Addendum No. 1

Nicetown Park Renovations

Philadelphia Redevelopment Authority

Issue Date: February 26, 2024

DRAWING NO.
C-1.1

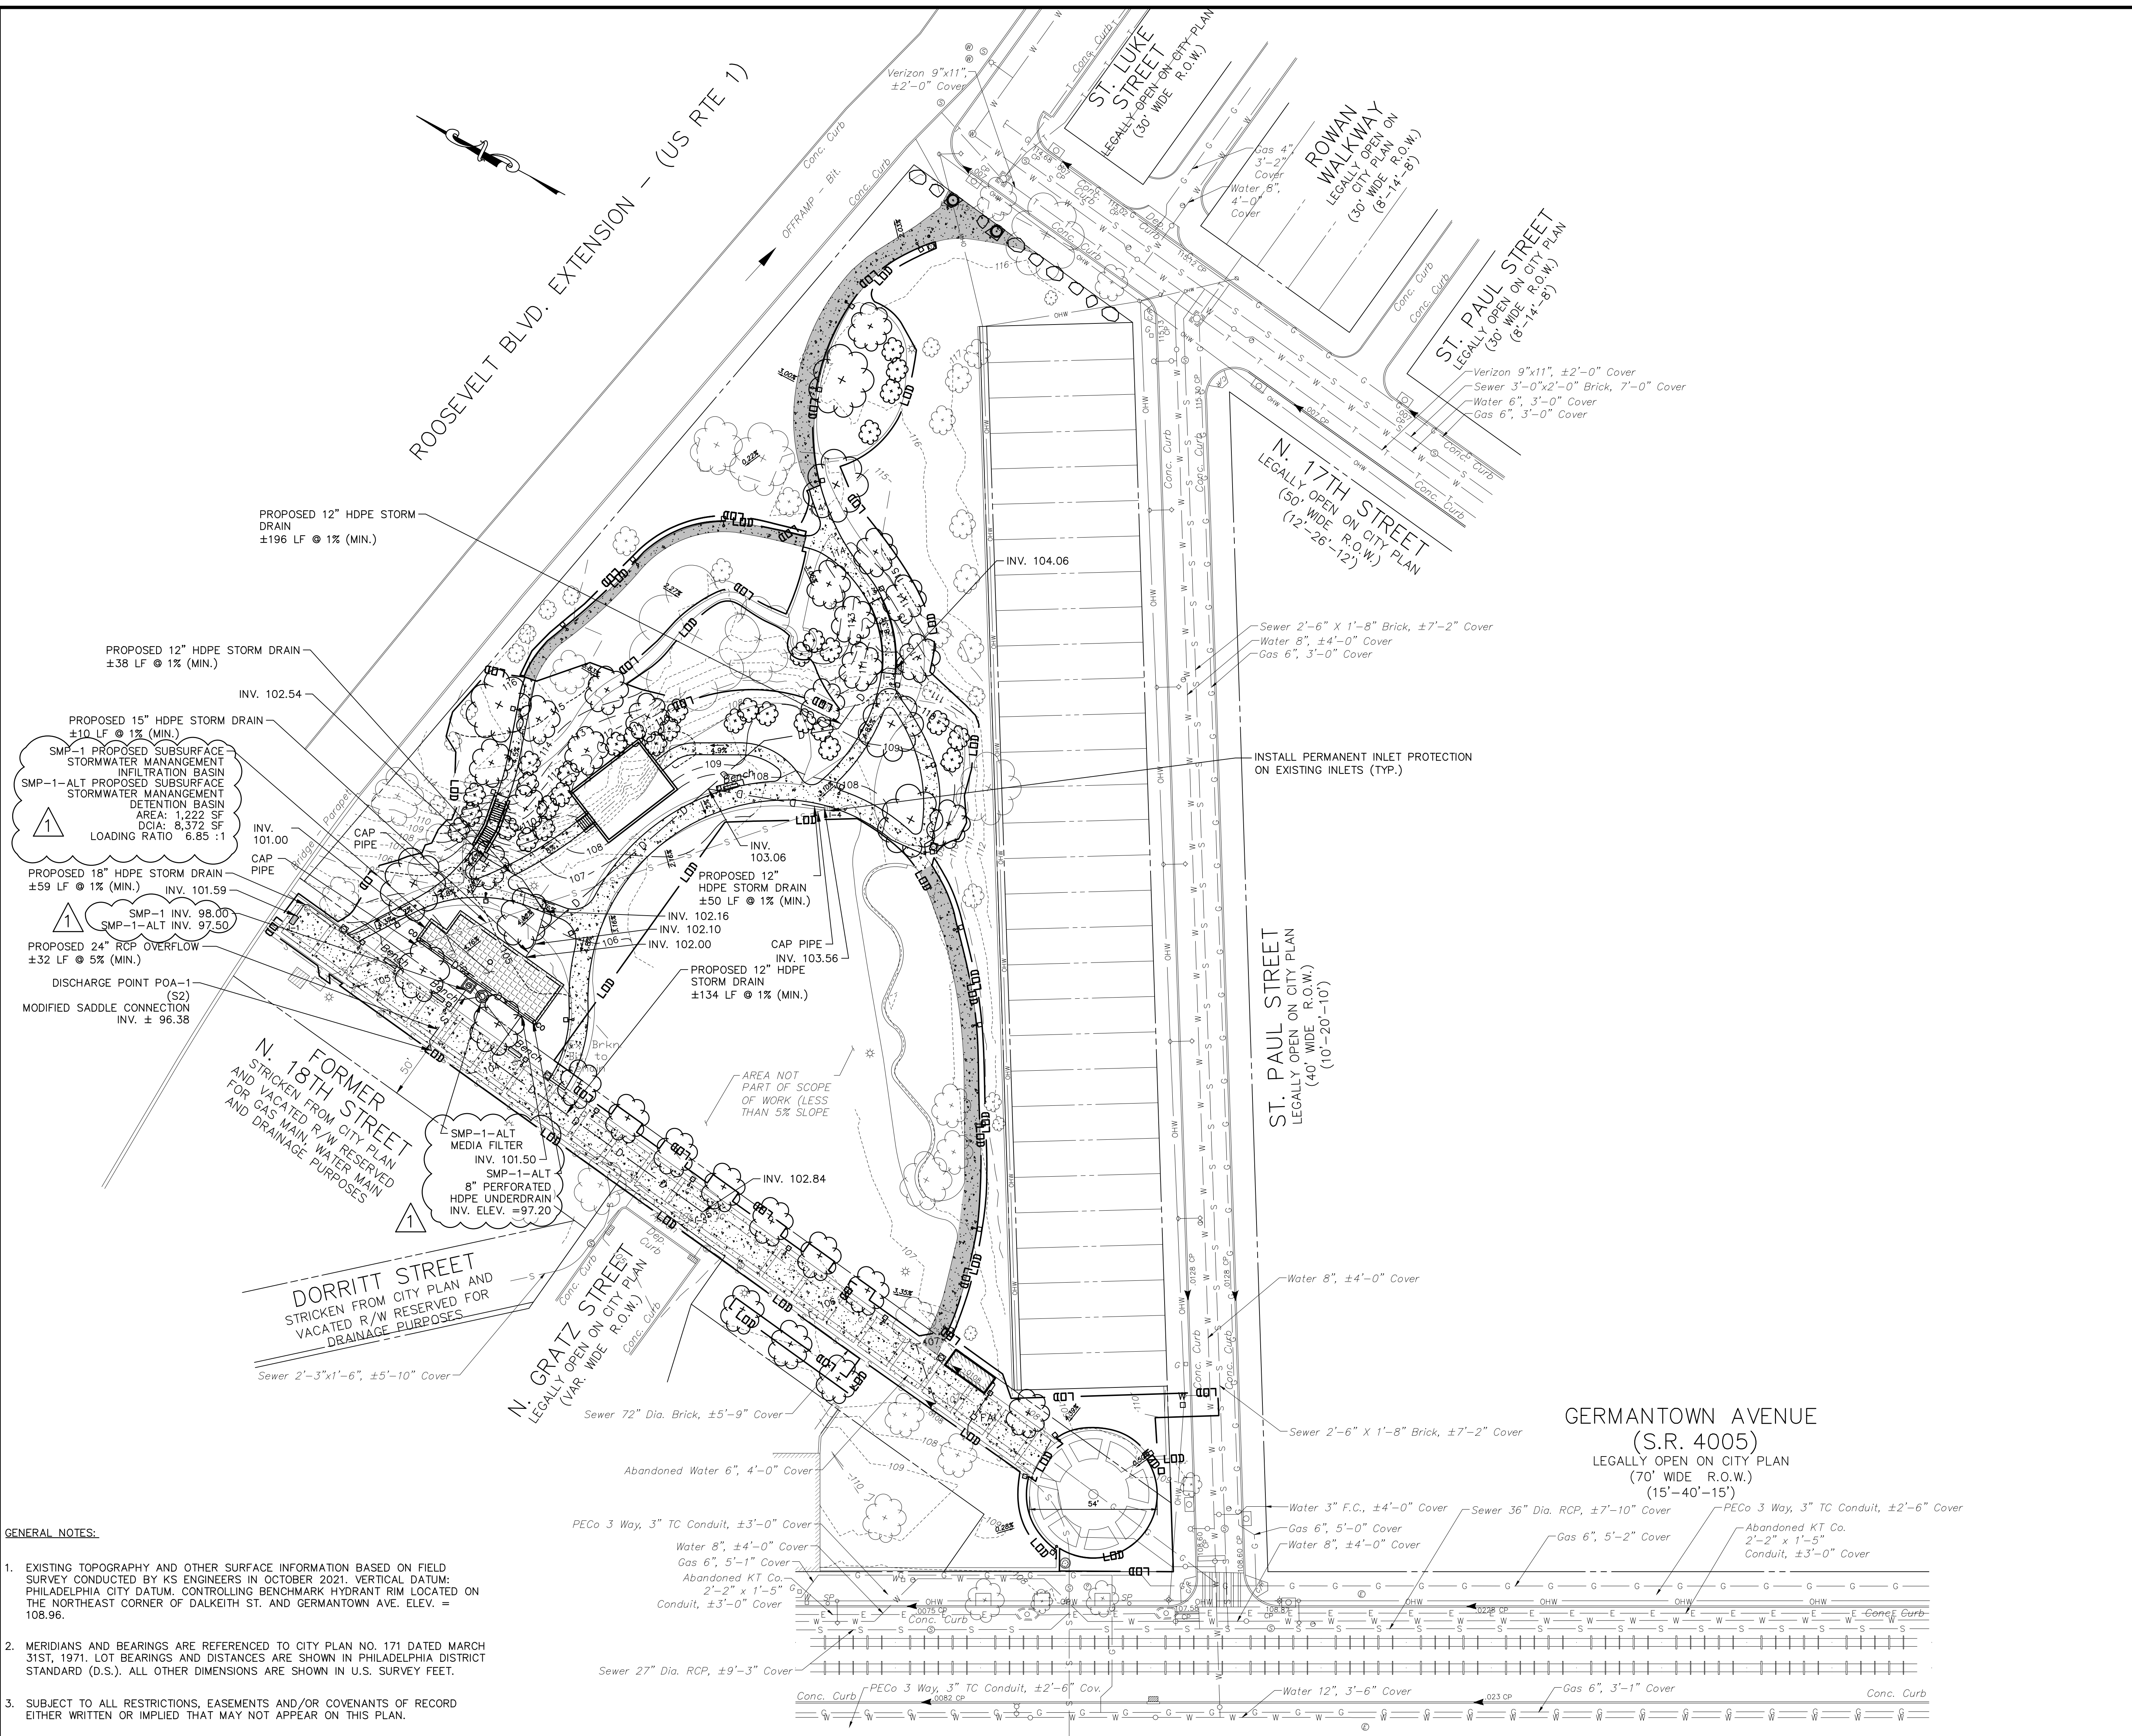
- Added a callout for SMP-1-ALT
- Added a callout for Outlet Structure OS-1-ALT
- Added a callout and symbol for Media Filter MS-1-ALT

KSE PROJECT NO. 2471-02	DRAWING NO. C-2.1
DATE 01.19.2024	SCALE 1" = 30'-0"
DRAWN BY KSE	CHECKED BY RSB
NOTE: ALL DIMENSIONS AND COORDINATE DATA IS BASED ON THE PHILADELPHIA CITY DATUM.

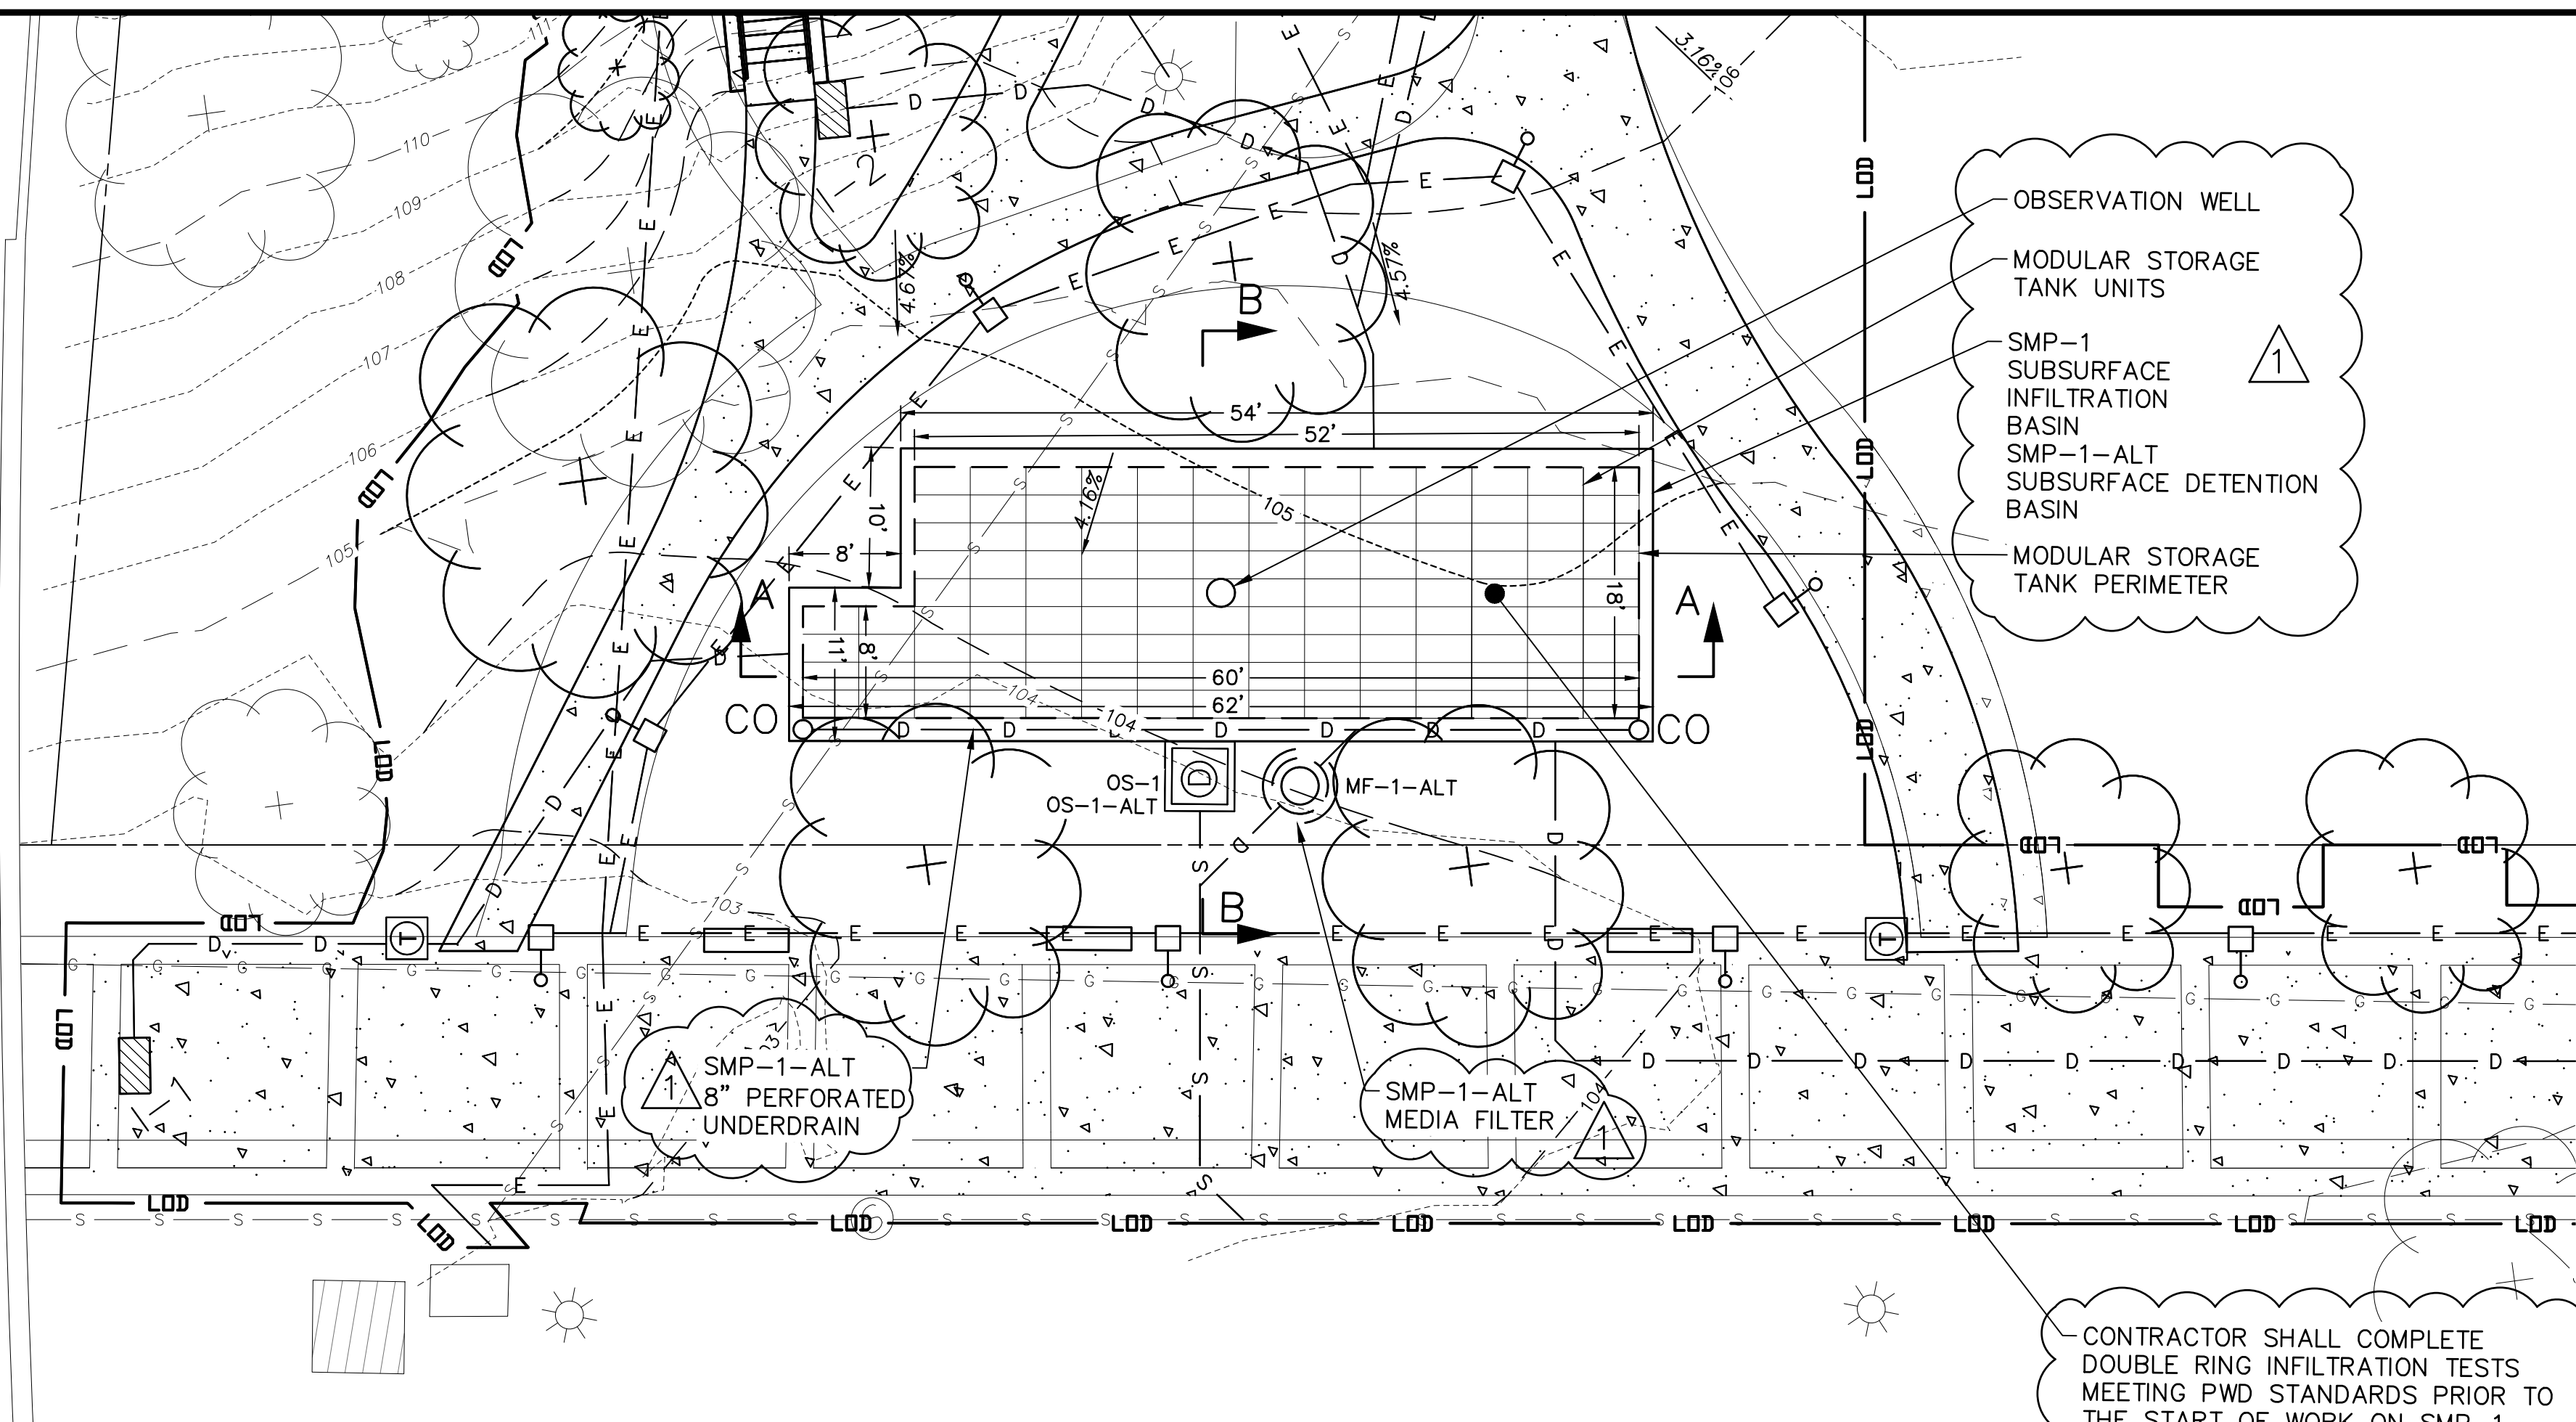
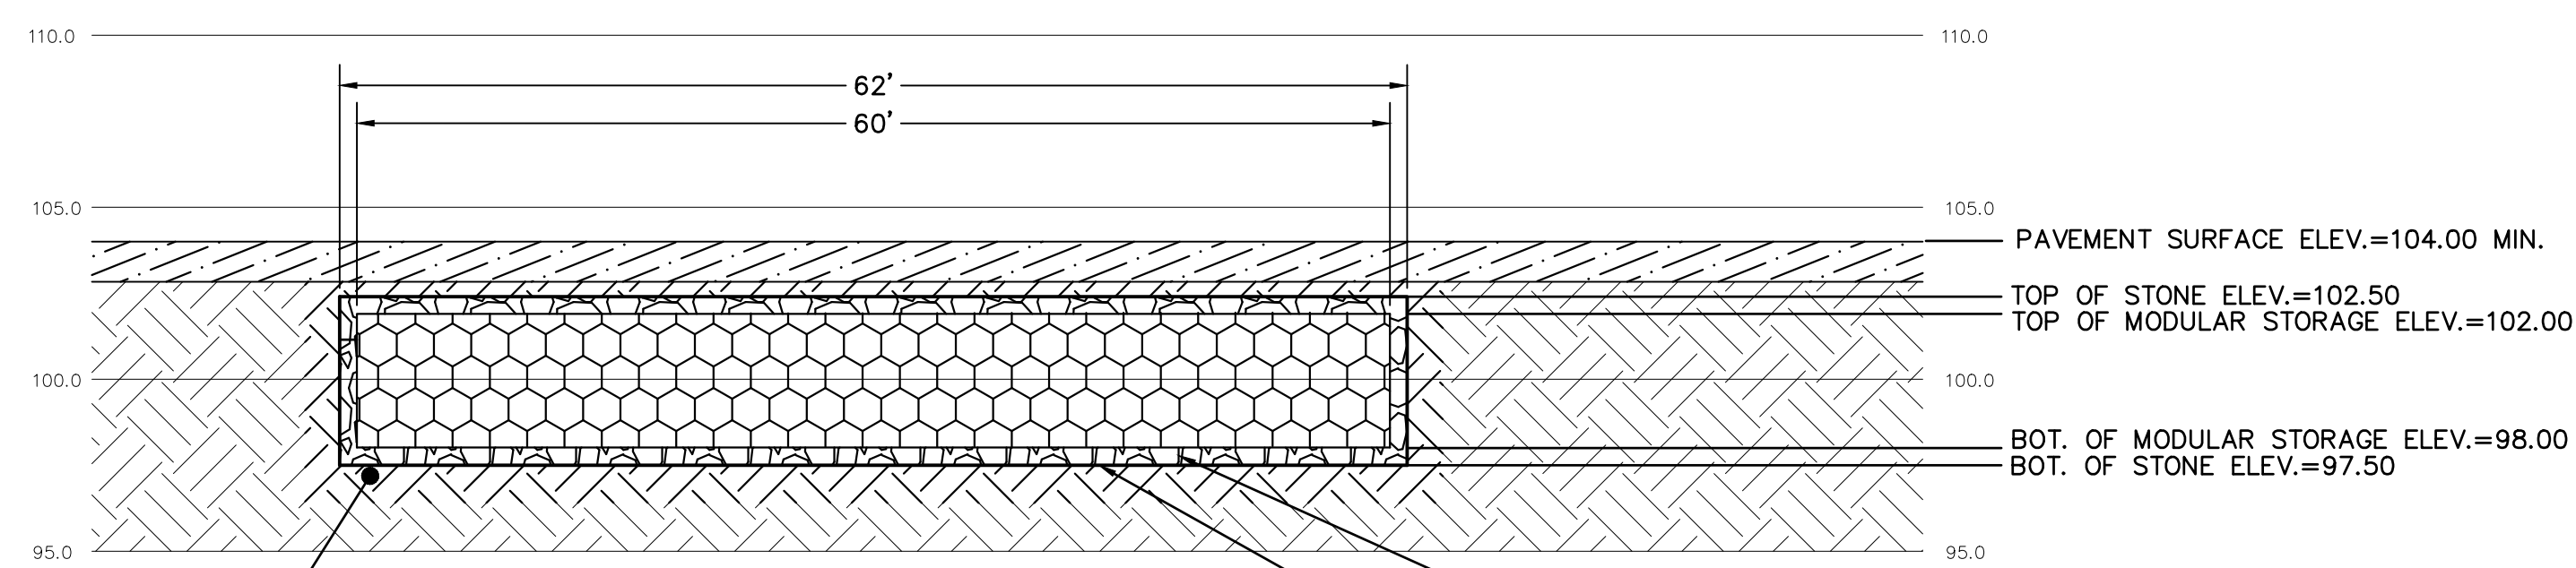
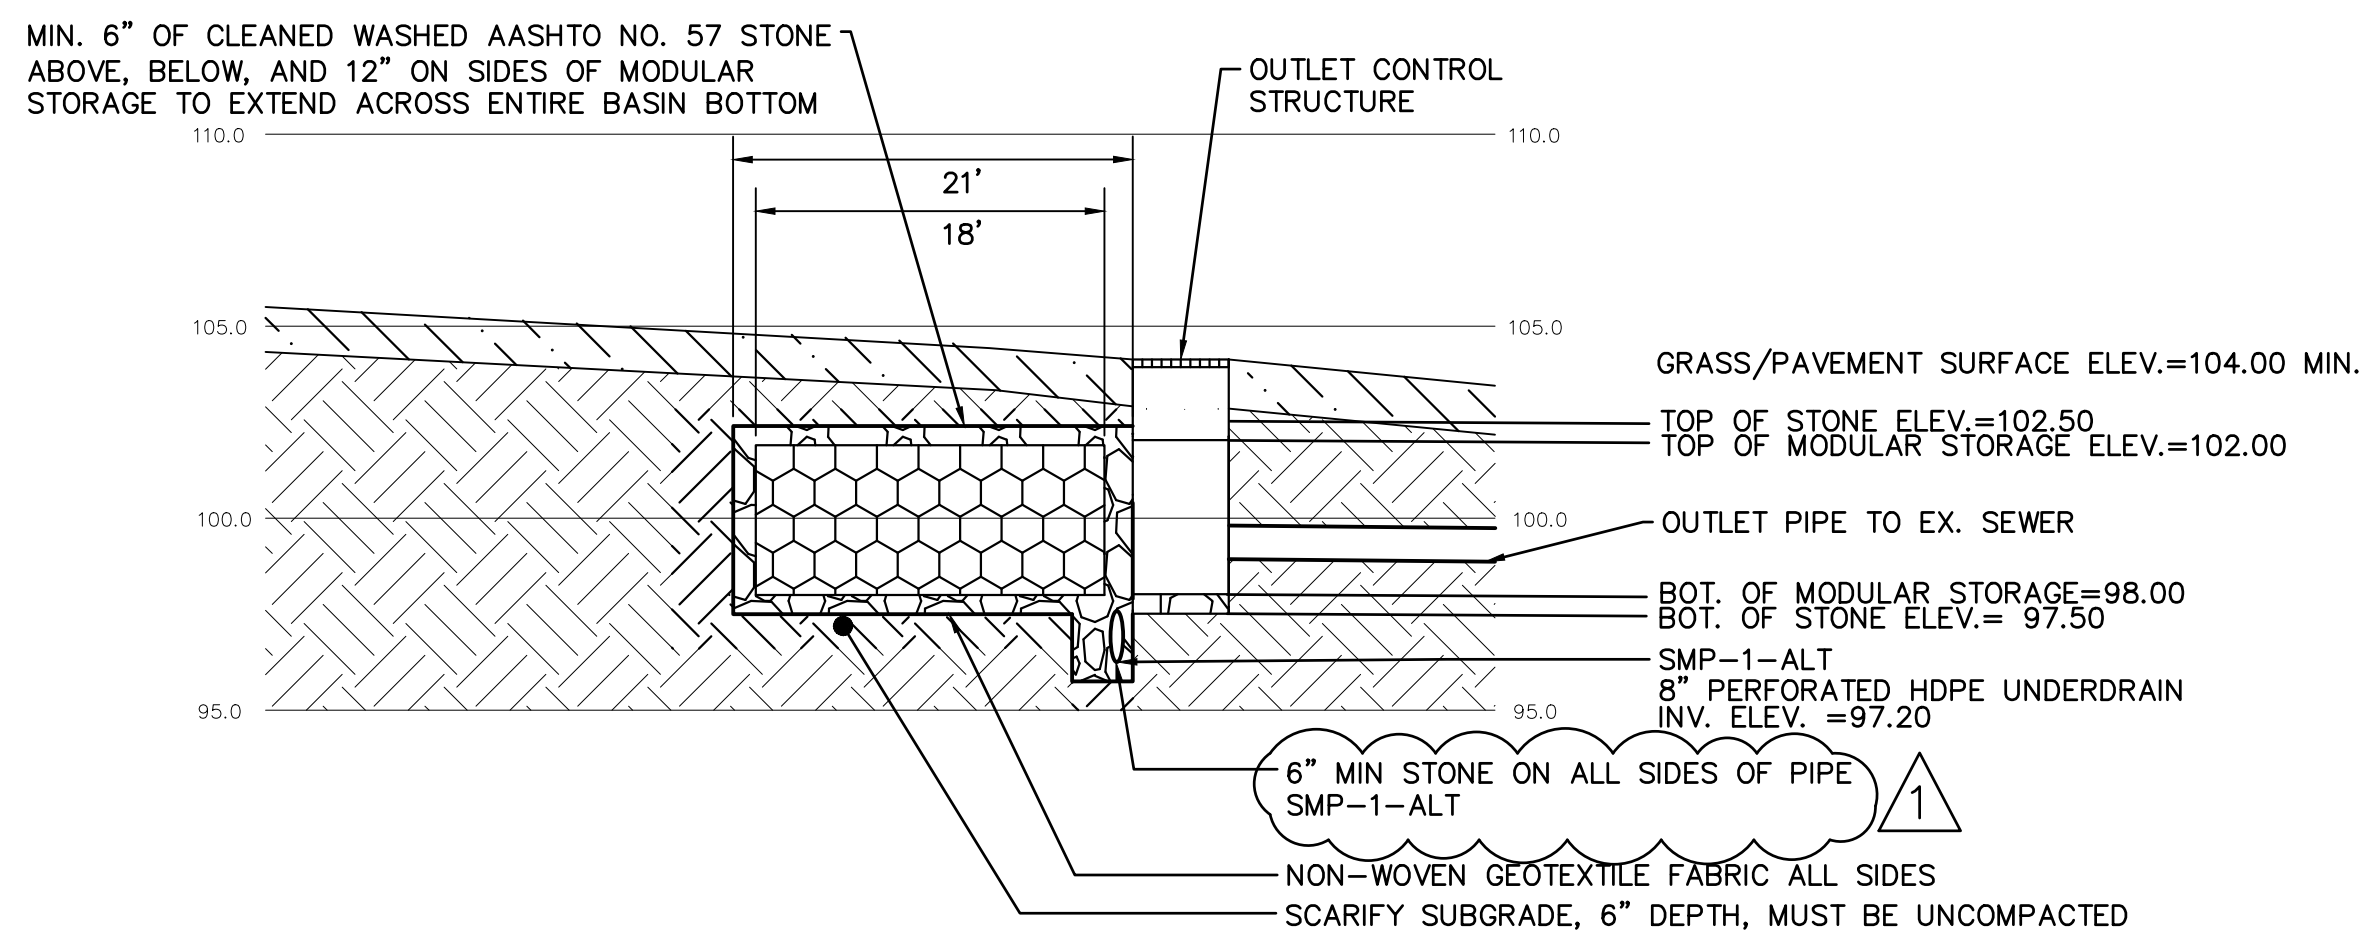
- Added a callout for SMP-1-ALT
- Added a callout for SMP-1-ALT Invert Elevation
